From: Wally Bridgewater (Adaptec)
To: X3T10 Membership
Subject: Proposed Change for Setup Time Budget
Date: 12/16/95

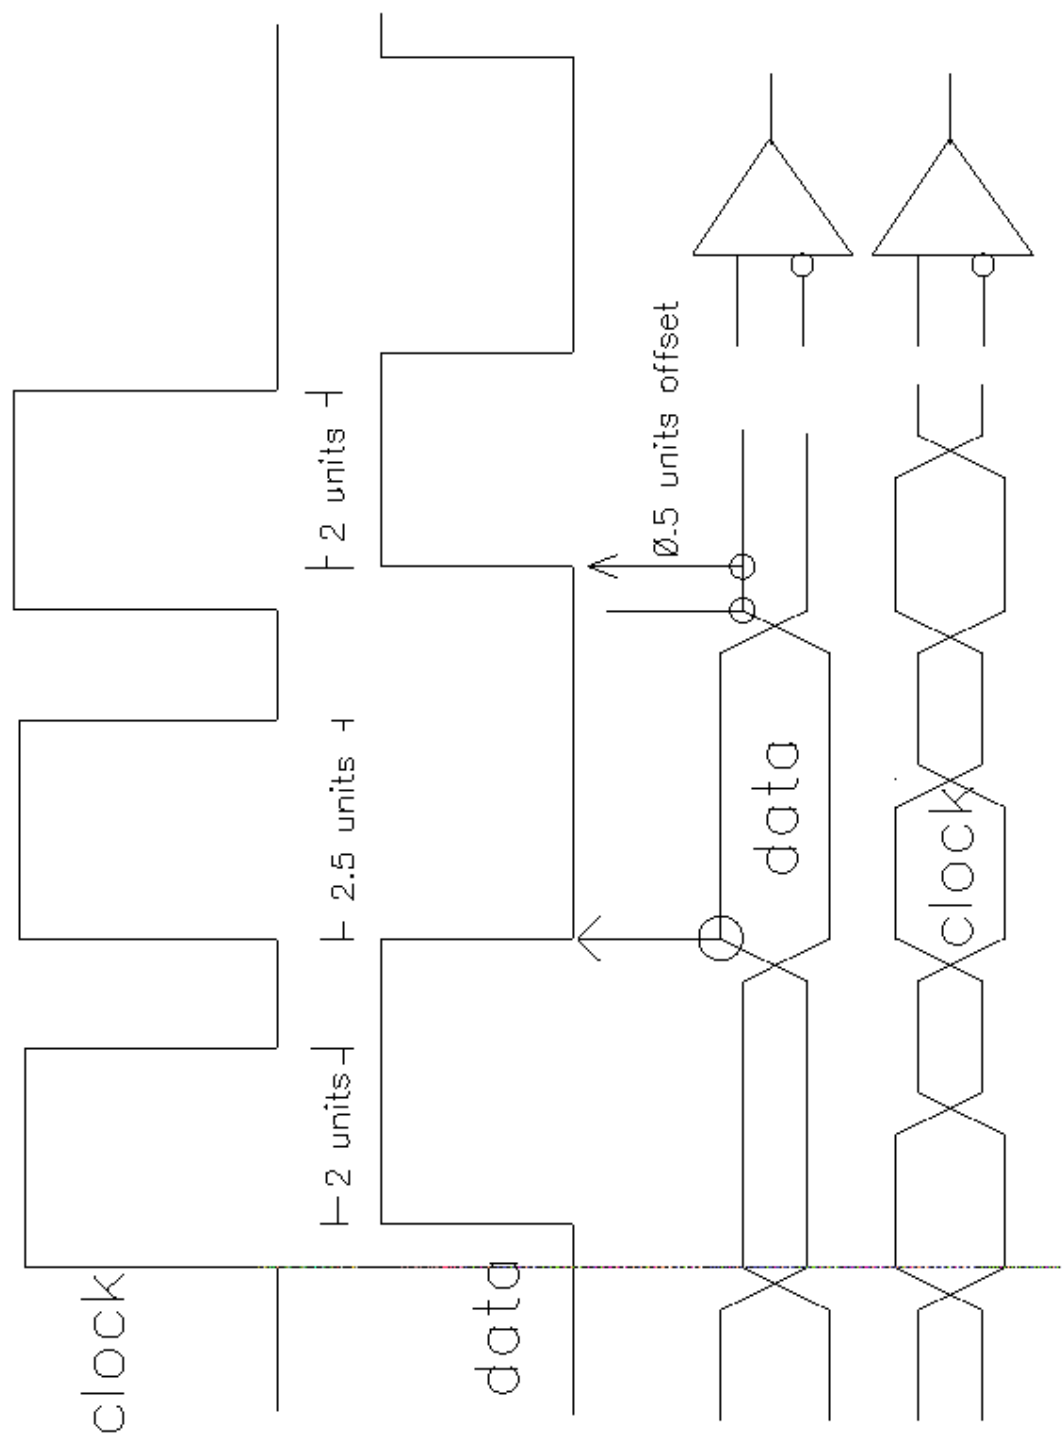
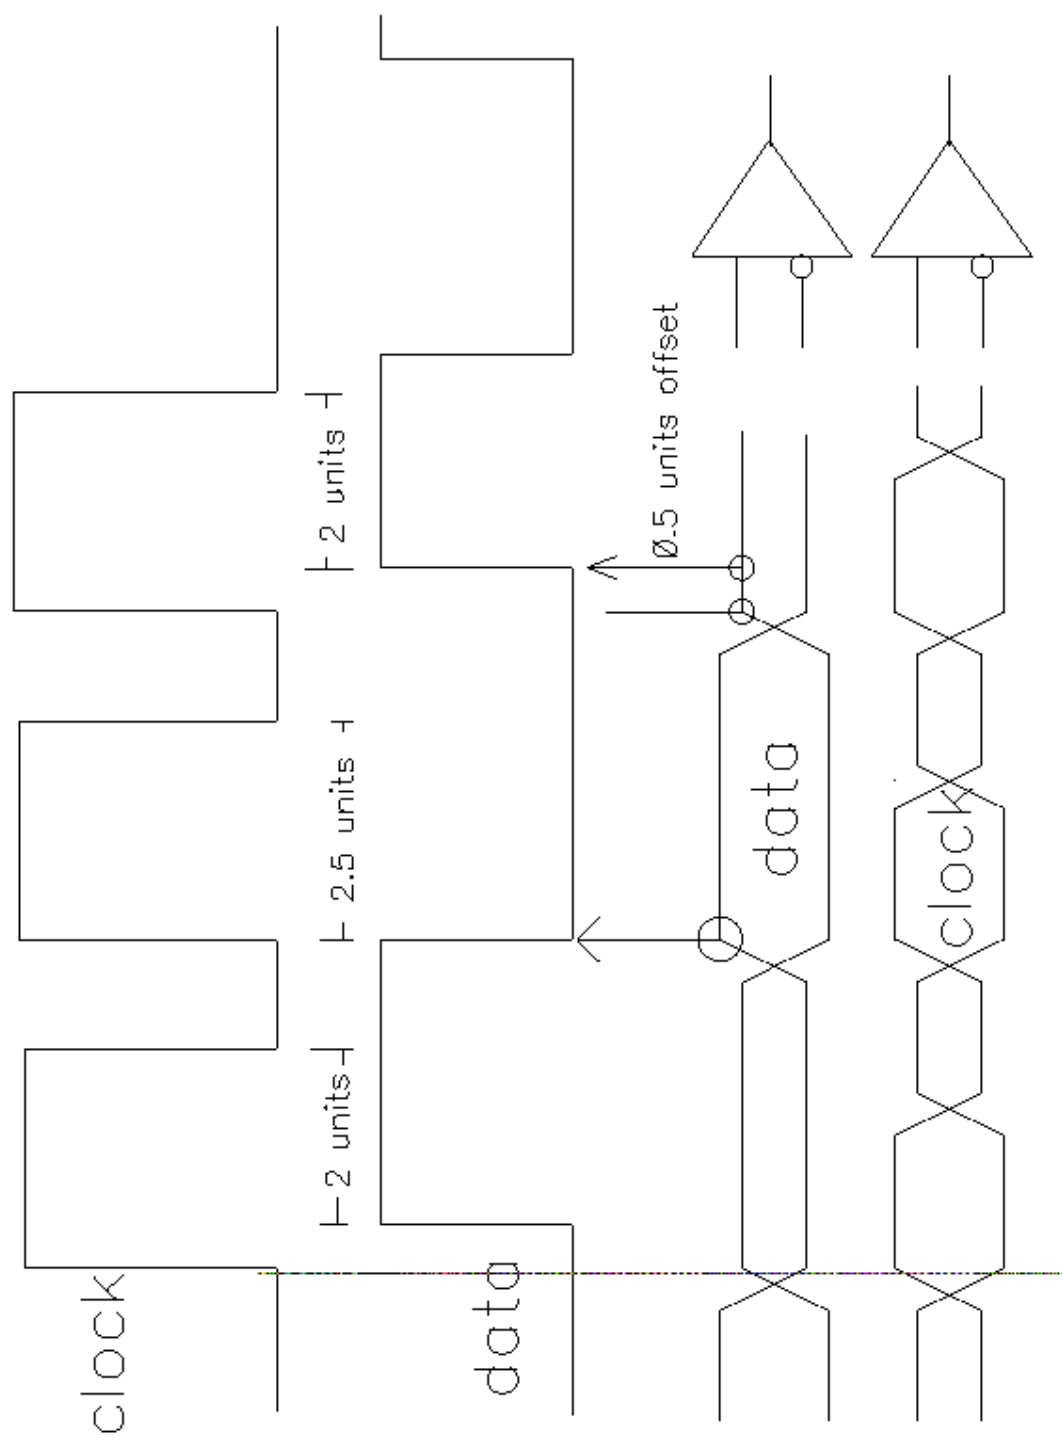
Use a correlated double sampler type receiver

--> much more difficult than less setup time
